2. Item A – Proposed Site Development Plan For Conifer Westminster Way, LLC, (Westminster Way Apartments)
   Item A – Proposed Site Development Plan for Conifer Westminster Way, LLC, (Westminster Way Apartments)

Subject: Proposed Site Development Plan for Conifer Westminster Way, LLC

Conifer, represented by Maser Consulting P.A., has applied for review of a proposed Site Development Plan (S-19-0012) for the Westminster Way Apartments, which contains 35 multifamily units and ground floor parking. The site consisting of the five parcels referenced above are zoned R-10,000 Residential and have been designated in the Compatible Neighborhood Overlay Zone as part of case LMA 19-01. Please note that a plat has been submitted to the City for lot consolidation and the approval of this plat is listed as a condition to site plan approval below.

RE: Development Design Preferences Manual Modification Request
Westminster Way Apartments
322 W. Main Street
Westminster, MD 21158
MC Project No.: 18001831A

SHEET TITLE:
EXTERIOR ELEVATIONS

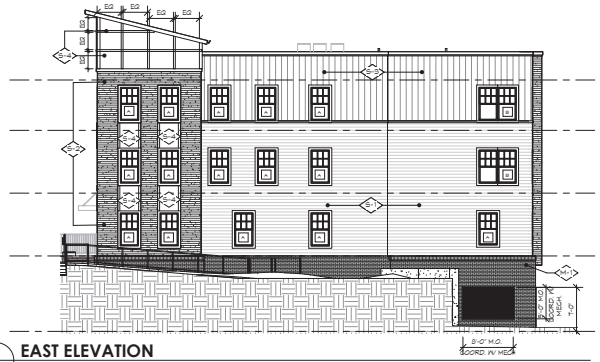
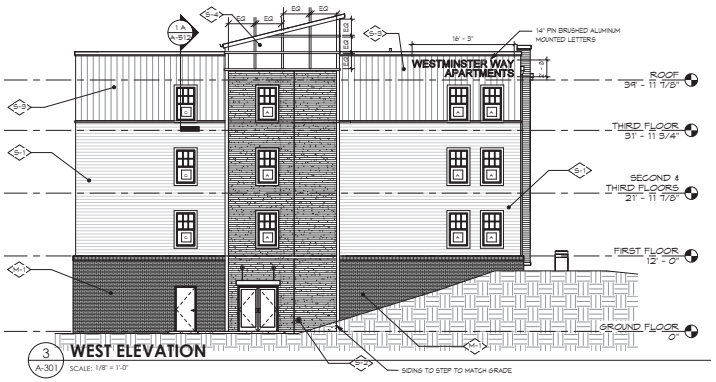
Modification of Adopted Preferences (2016 Development Design Preferences Manual)	
Standard	Staff Comment
Per page #25, Including building elements of various heights within the overall project design is encouraged	Please add varying heights similar to what is provided for on the West Main Street frontage.

Per page #27, Roof-lines should be segmented and varied within an overall horizontal context. Varying heights are encouraged	Please add varying heights similar to what is provided for on the West Main Street frontage.
The City prefers that loading docks, trash collection areas, outdoor storage and similar utility facilities and functions be incorporated into the overall design of the site. These facilities should be shielded from the public eye and kept out of view of adjacent properties and streets.	Please provide screening around the proposed transformer that will not interfere with the underground utilities.

The building has varying context as designed with different materials at the north and south elevations including two colors of concrete siding, one color of vinyl siding run horizontally, one color of siding run vertically, brick as well as paneling at the towers and at the bump outs. If further varied context (siding/façade) is required, please consider a modification request for this

The building has varying heights on all sides with the book end towers on the far east and west sides providing relief to the east and west elevations. However due to the solar panel collector design, we do not believe any further building height modification can be achieved.

TRANSFORMER LOCATION REQUIREMENTS

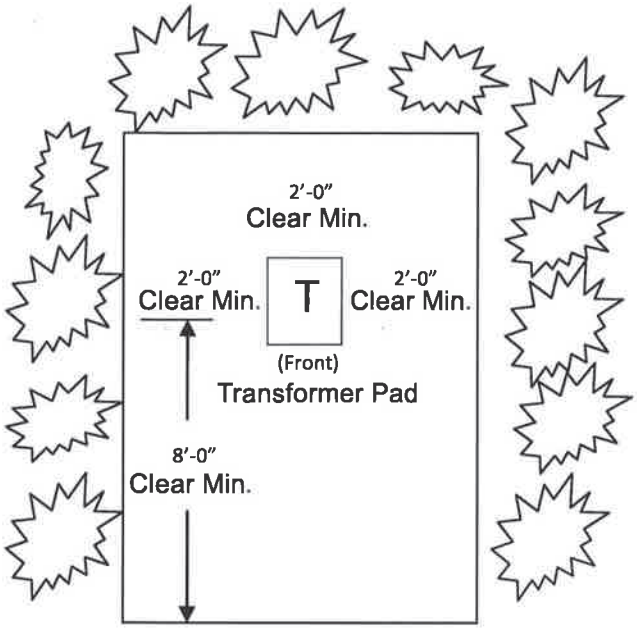
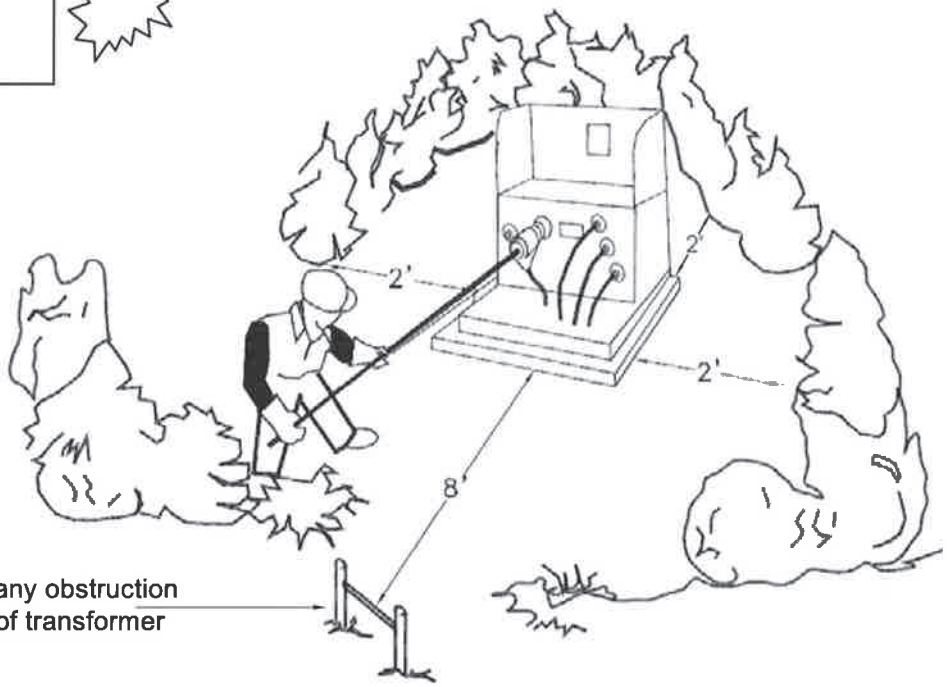
This modification request is specifically for the proposed electric transformer, located at the east end of the building. The transformer has been located to minimize interference with basic site design criteria (pedestrian access to parking, vehicular sight distance, ADA access, etc.) as well as to provide a siting in proximity to the mechanical room, which is located at the eastern end of the building. Due to these space limitations and the additional work zone clearance requirements around the transformer (see attached excerpt from BGE's "Natural Gas and Electric Service Guide"), we hereby request a modification to incorporate the transformer fully into the overall design of the site.
